City of Cranston

# City Plan Commission

September 1, 2020

# Replat Oaklawn Plat Lots 86, 87, 88, & 89

# SUBDIVISION PLAN

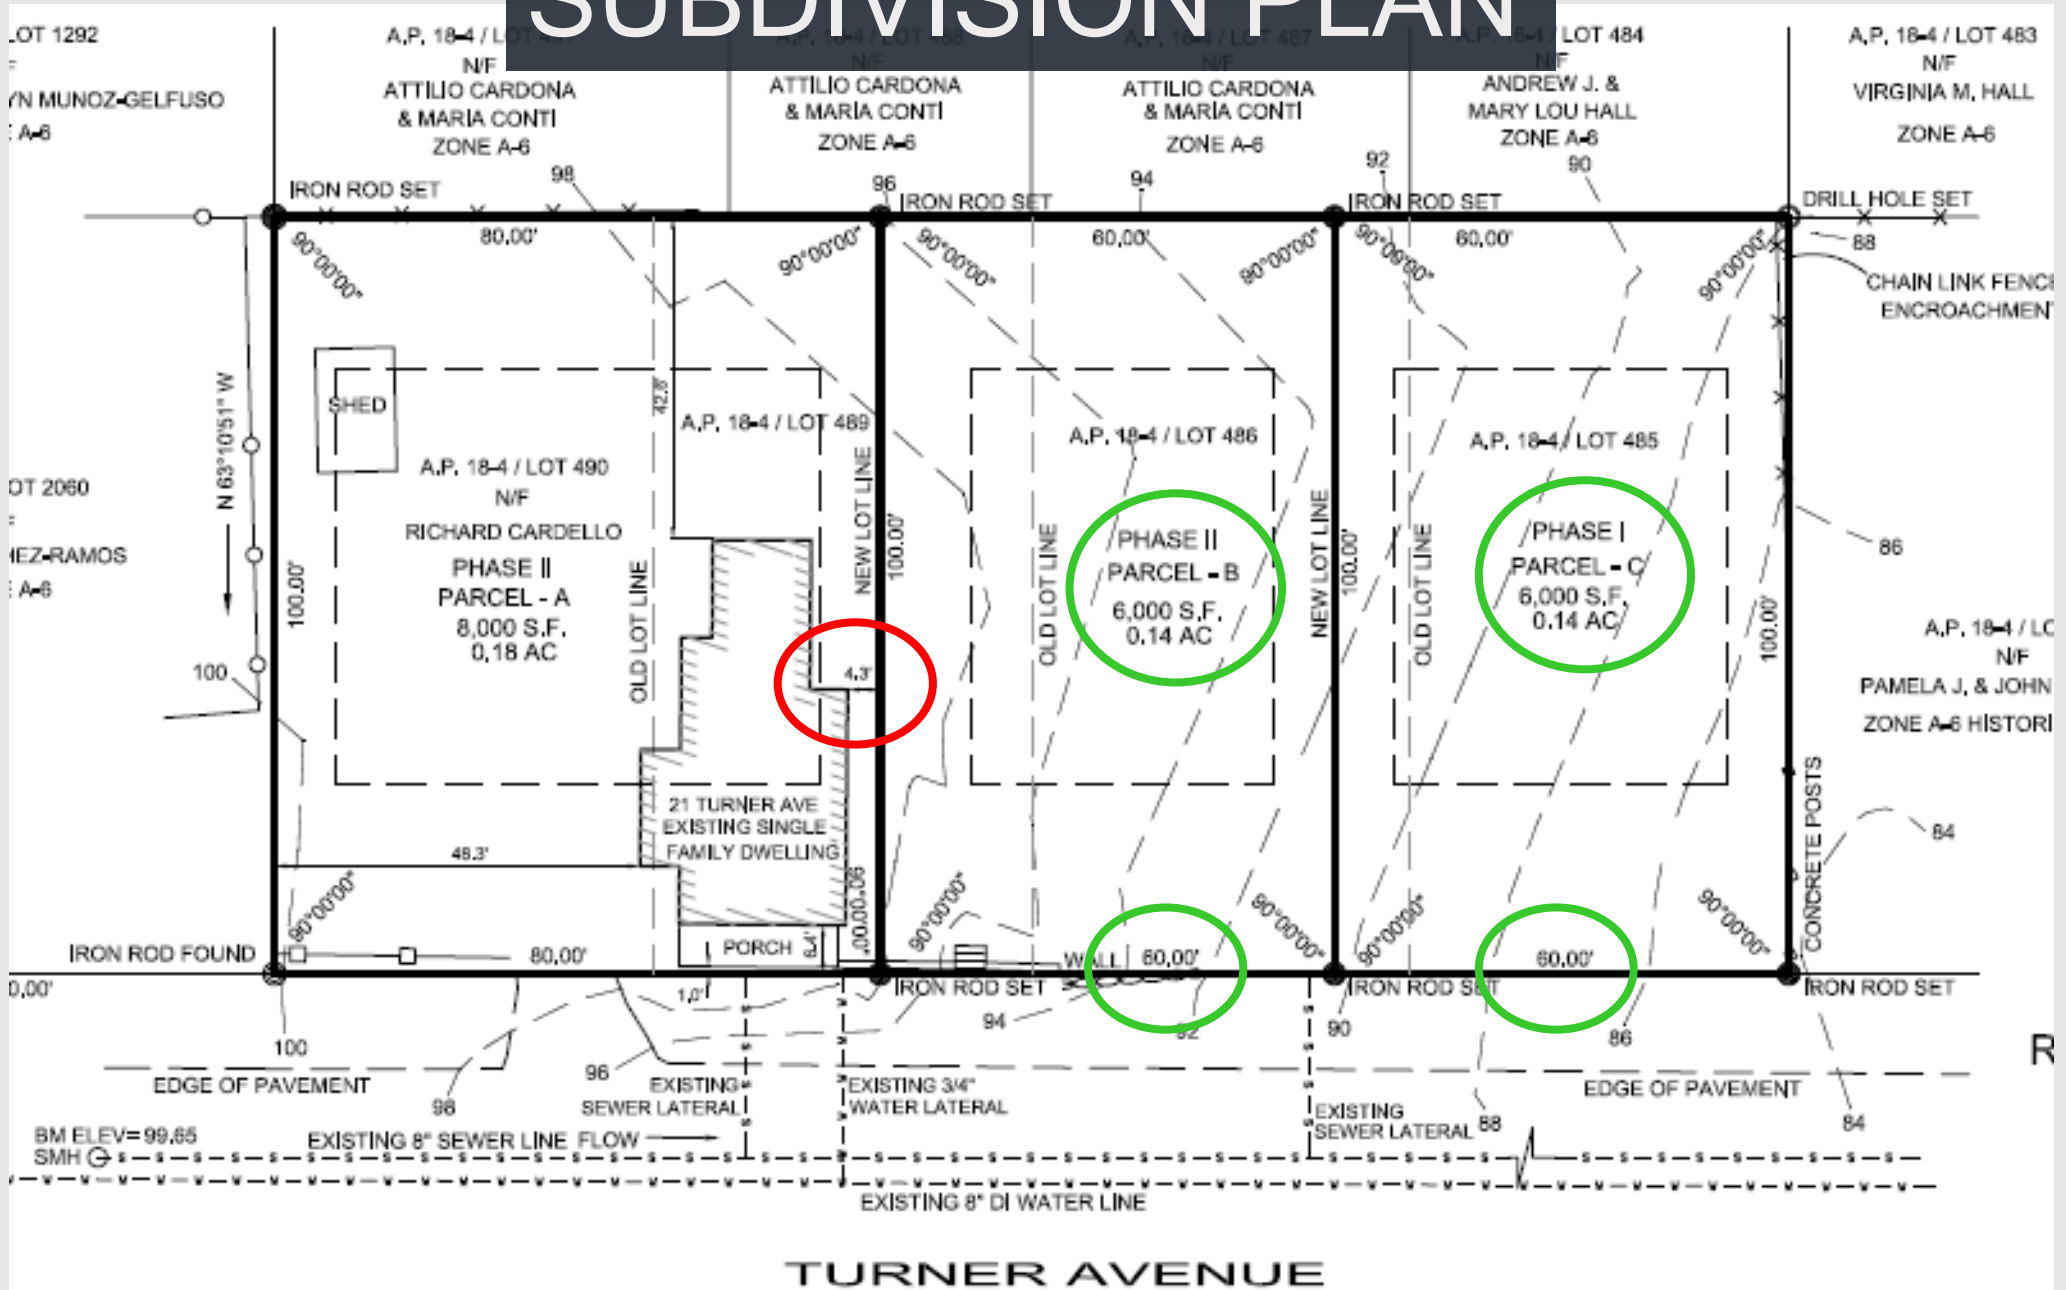
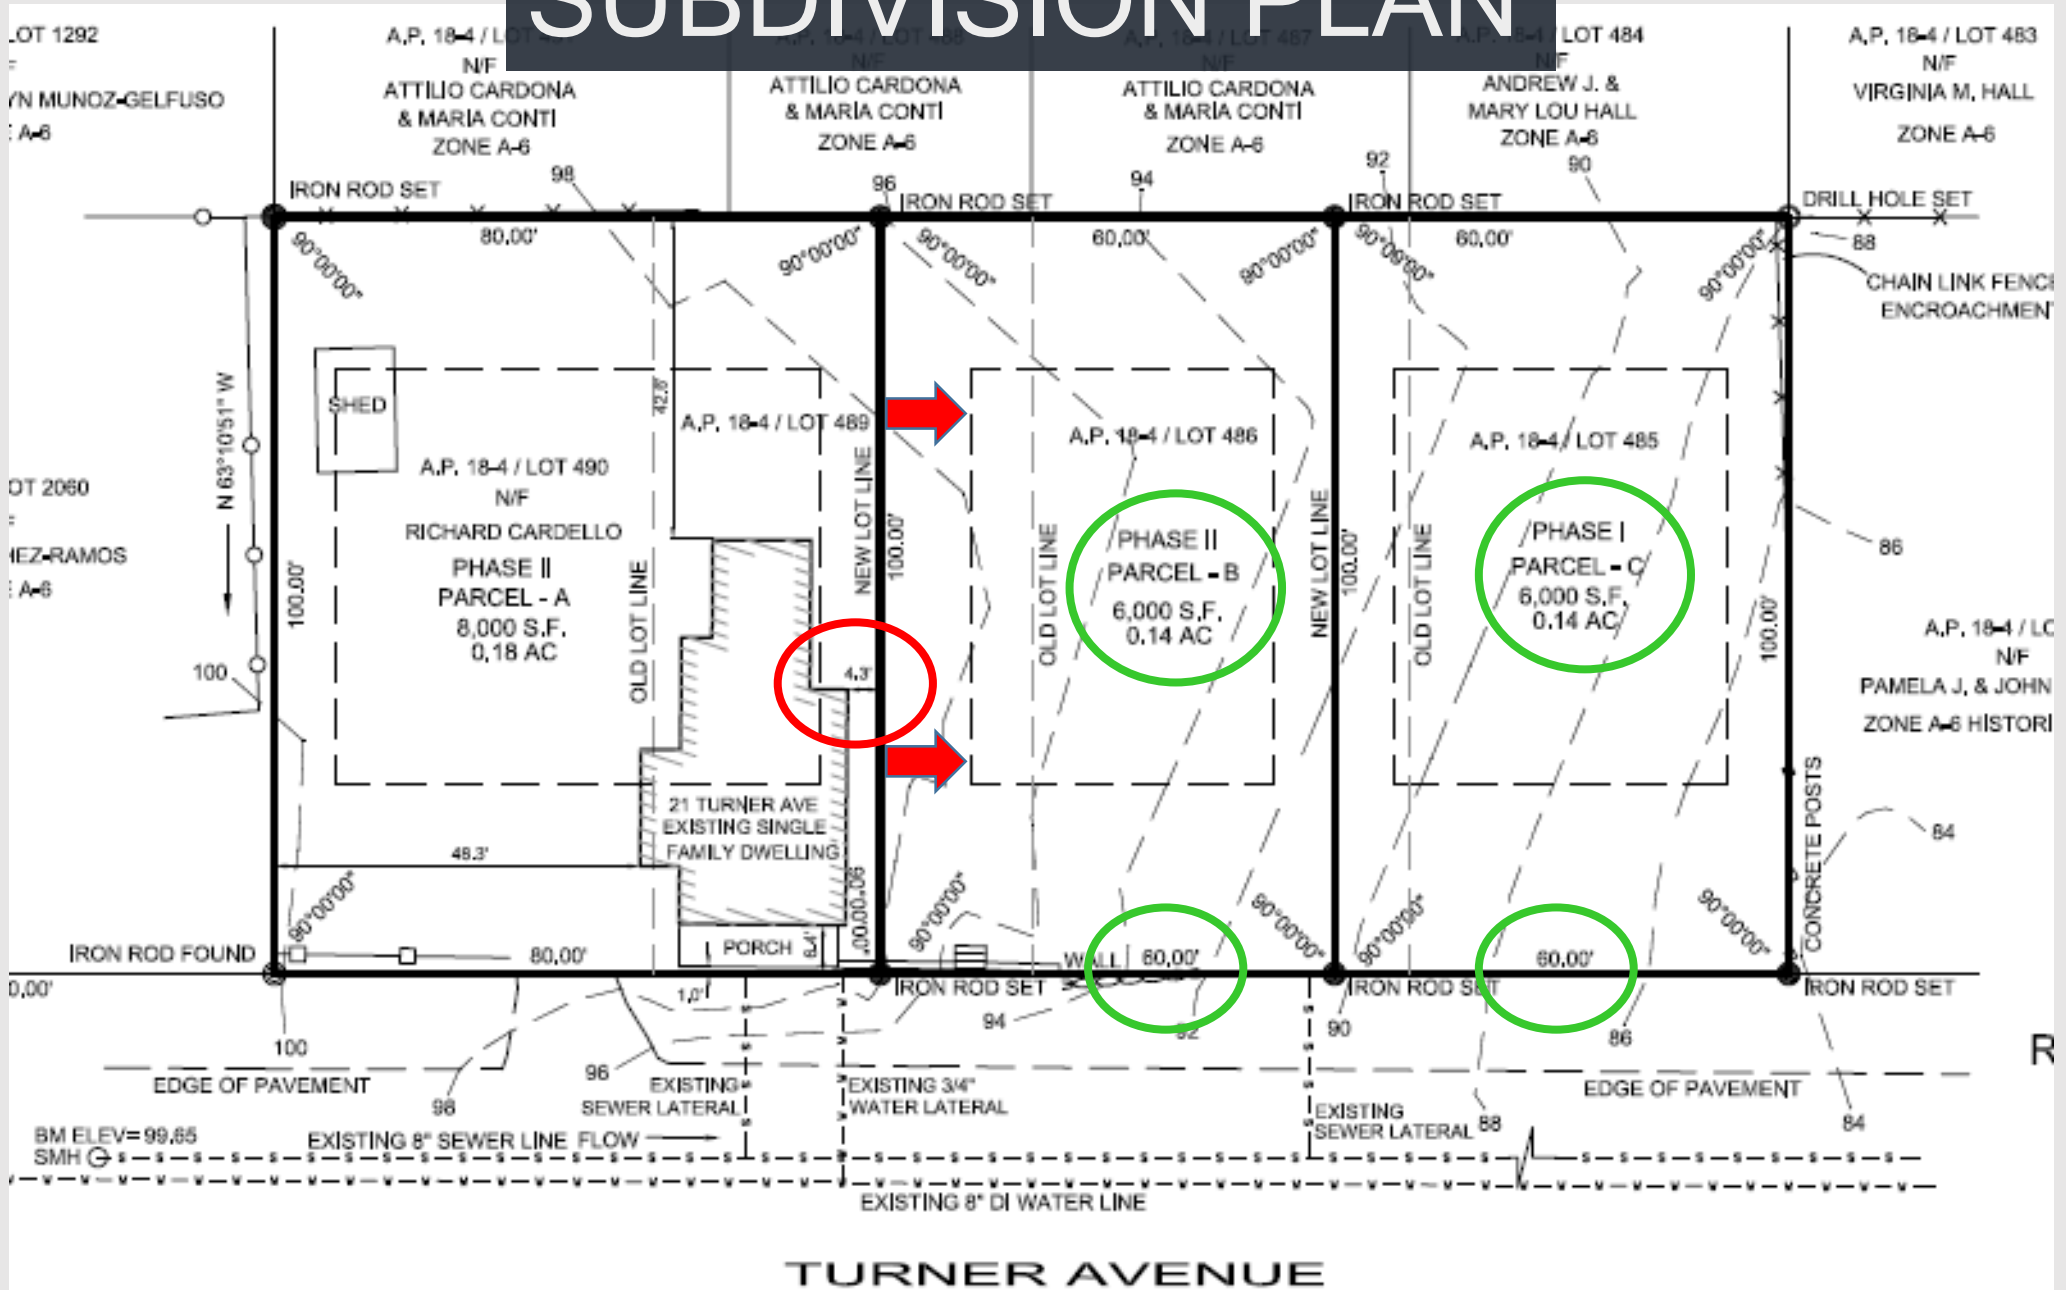
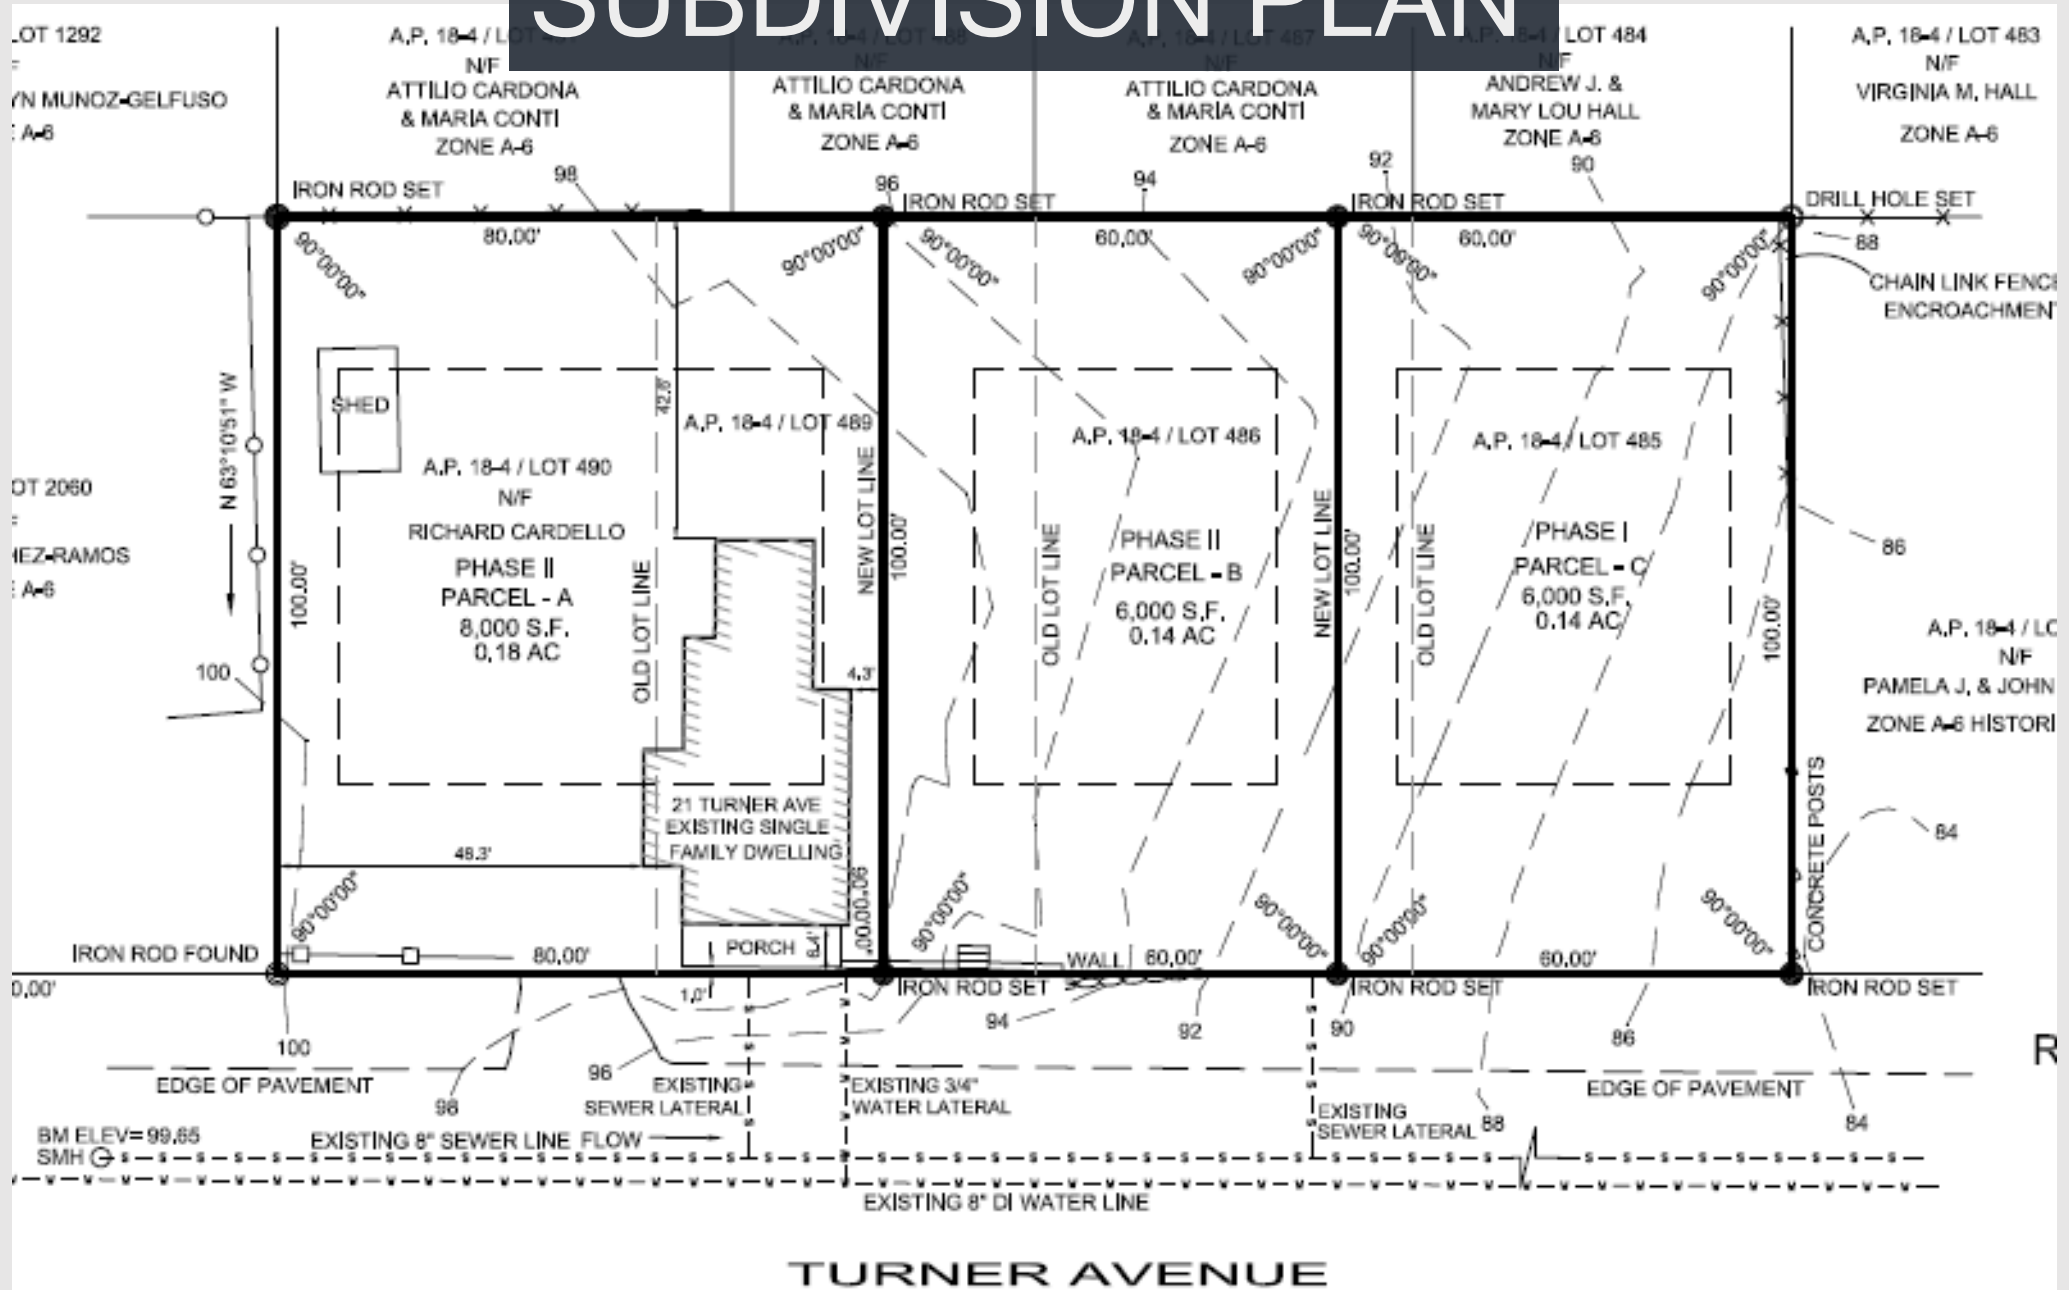
- All of the proposed lots meet or exceed A-6 zoning requirements.
- The proposal is consistent with the FLUM allocation of Single Family Residential at 3.63 to 7.26 units/acre with a proposed density of 6.53 units/acre.
- The project site does not contain historic, cultural or natural features which would require preservation.
- None of the properties in the area have sidewalks or curbing, therefore staff supports waivers from the sidewalks & curbing requirements.

- The subdivision does NOT rely on zoning relief – relief ONLY determines whether the house can remain or will be demolished & rebuilt.
- The applicant proposes to offset the encroachment on the adjacent lot.
- The relief requested is the minimum relief necessary to keep the residence.
- Relief is consistent with Comprehensive Plan Housing goal HG-5, “*Conserve housing resources, especially affordable housing units, to preserve the base housing stock, as the costs of locating and constructing new housing units are significant.*”
- Denial would amount to more than a mere inconvenience.
- Denial would be wasteful and inefficient in terms of resources.
- Denial may not mitigate concerns previously voiced by the neighbors.

1. The applicant shall receive the necessary relief from the Zoning Board of Review for the encroachment of the existing residence into the side yard setback on Parcel A. Should relief be granted, the adjacent side yard setback for proposed Parcel B shall be 12 feet instead of 8' feet. If relief is denied, the existing residence must be demolished or relocated as to eliminate the encroachment into the side yard setback and the side yard setback for Parcel B will be 8'; and
2. The applicant shall pay the Eastern Cranston Capital Facilities Impact Fee in the amount of \$1,186.92 (\$593.46 per new buildable lot) at the time of Final Plan recording.

# SUBDIVISION PLAN

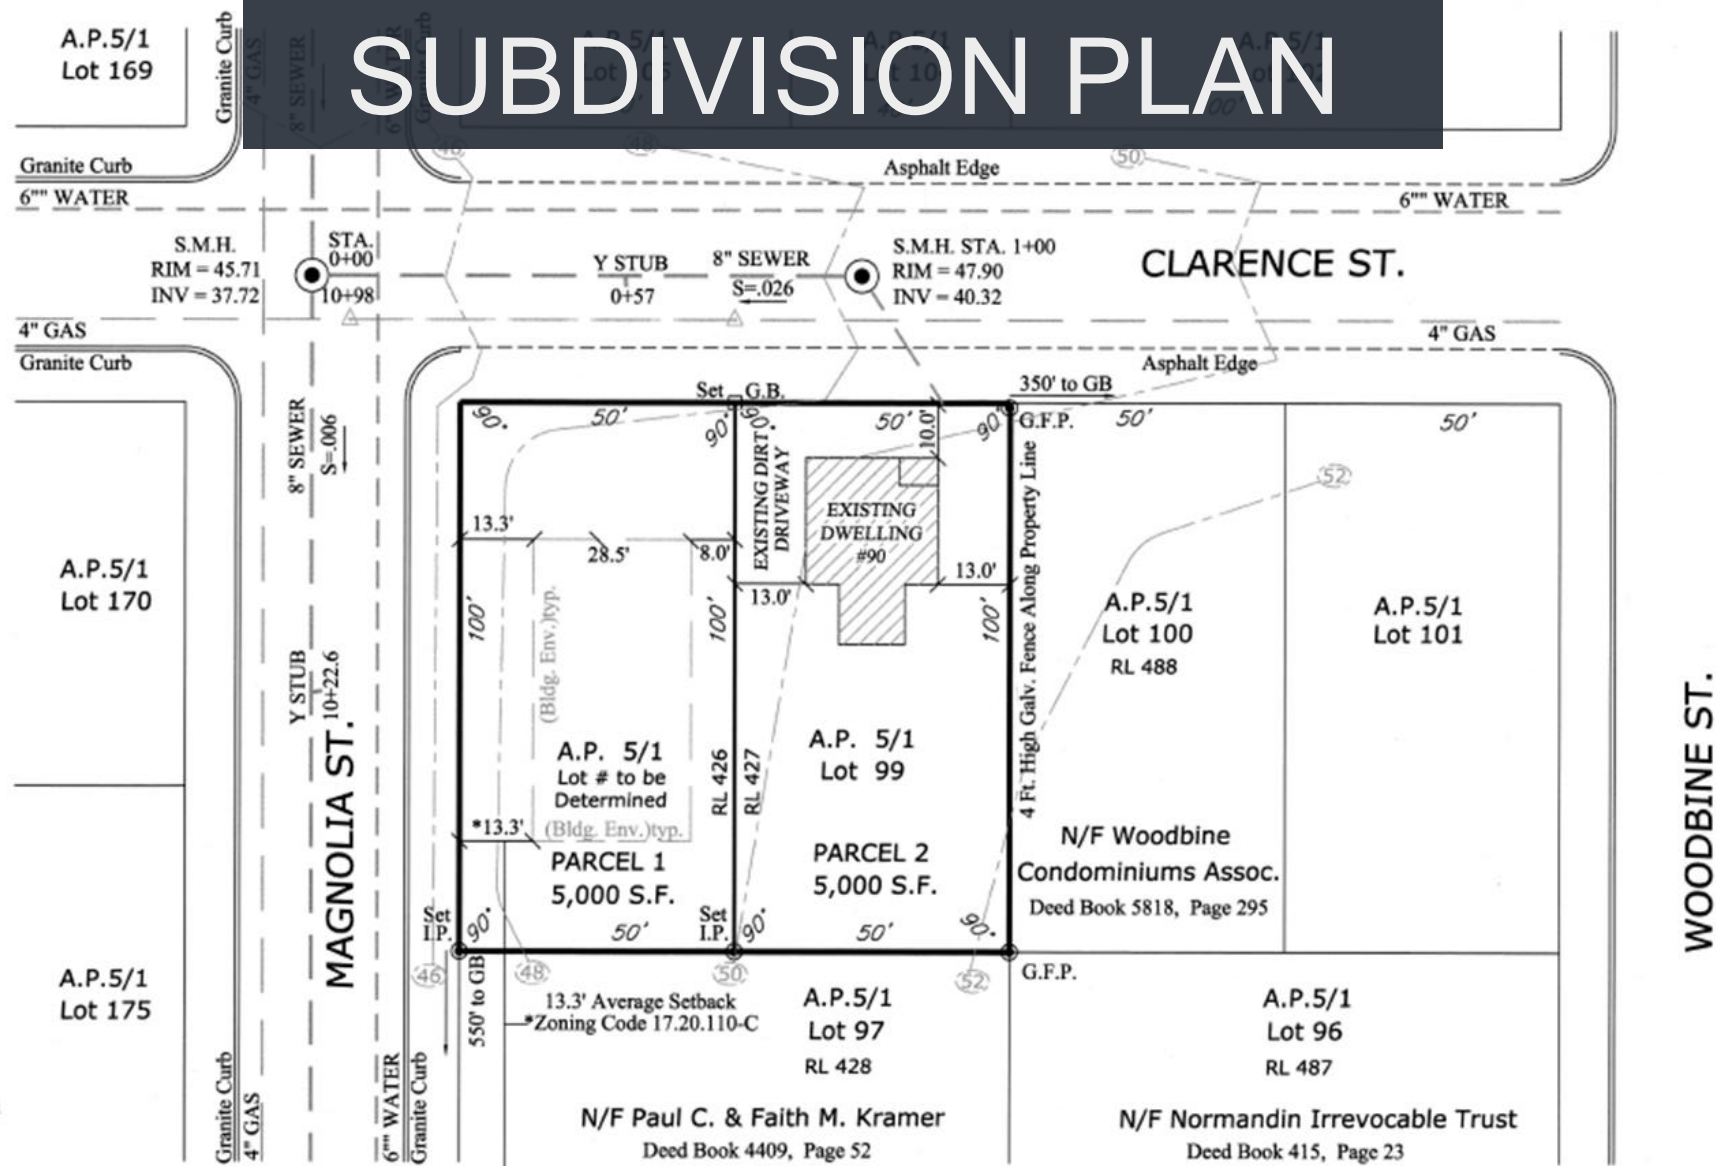
- Proposal is to subdivide a single 10,000 ft<sup>2</sup> lot with an existing single-family house into two 5,000 ft<sup>2</sup> lots, where 6,000 ft<sup>2</sup> is required.
- The lot with the remaining house (Parcel 2) will be substandard in frontage in which 50' is provided where 60' is required.
- The applicant has provided a neighborhood analysis that shows that 79 of the 101 lots within 400' are exactly 5,000 ft<sup>2</sup>.
- The Cranston Comprehensive Plan's Future Land Use Map designates the subject parcels as "Single/Two Family Residential Less Than 10.89 units per acre". The proposed density of the project is 8.71 units/per acres so the project is consistent with the Comprehensive Plan.

1. Applicant shall receive variance approval for substandard lot area and frontage from the Cranston Zoning Board of Review prior to filing the Final Plan Application with the Cranston Planning Department.
2. Payment of the Eastern Cranston Capital Facilities impact fee in the amount of \$593.46 (1 new unit) must be submitted at the time of final plat recording.
